Access Compliance Report

Public Rights-of-Way

(Curb Ramps)

Intersection ID: 11362	Main Street: CALLISON_CT	Cross Street: TIMBERTOP_LN	Location: SW
ADA ID: E323796A3A14	Ramp Type: Perp	Initial Pass/Fail: Fail	Overall Compliance: No
Severity Score: 55			
Codes/Mitigation Info/Possible Solution		Field Measurements/Component Compliance

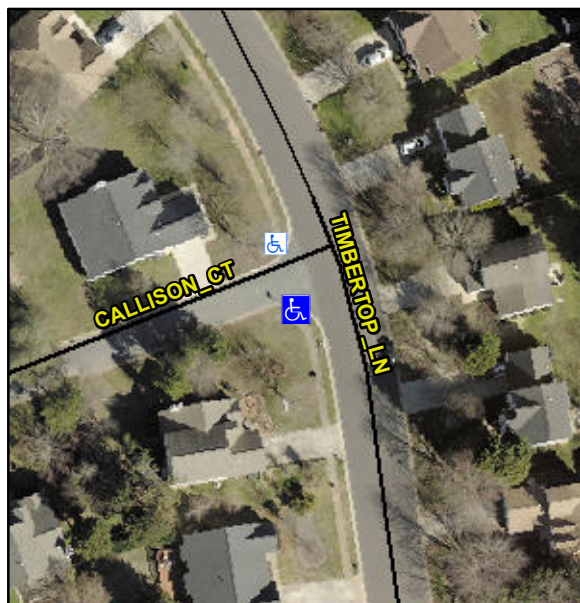
Not Found, R304.5.1, R304.2.2, R304.5.3

Compliance	Description	Data	Compliance	Description	Data
N/A	Ramp Length (in)	52.0	No	Ramp Slope (%)	8.4
No	Ramp Width (in)	32.0	No	Ramp XSlope (%)	7.4
N/A	Flare Type LT	N/A	N/A	Flare Type RT	N/A
N/A	Flare Slope LT (%)	N/A	N/A	Flare Slope RT (%)	N/A
N/A	Flare Traversable LT?	N/A	N/A	Flare Traversable RT?	N/A
N/A	Landing Length (in)	N/A	N/A	DWS Provided?	N/A
N/A	Landing Width (in)	N/A	N/A	DWS Contrast?	N/A
N/A	Landing Slope (%)	N/A	N/A	DWS Length (in)	N/A
N/A	Landing X Slope (%)	N/A	N/A	DWS Full Width?	N/A
N/A	Landing Curb? (Y/N)	N/A	N/A	DWS Offset (in)	N/A
N/A	Shared Landing?	N/A			
N/A	Gutter Ponding?	N/A	N/A	Gutter Slope (%)	N/A
N/A	Gutter Lip Ht (in)	N/A	N/A	Gutter X Slope (%)	N/A
N/A	Painted X Walk1?	No	N/A	Painted X Walk2?	N/A
	X Walk 1 Direction	To N		X Walk 2 Direction	N/A
N/A	X Walk 1 Width (in)	N/A	N/A	X Walk 2 Width (in)	N/A
	X Walk 1 Slope (%)	0.3		X Walk 2 Slope (%)	N/A
	X Walk 1 X Slope (%)	2.2		X Walk 2 X Slope (%)	N/A

Remove & Replace Entire Ramp.
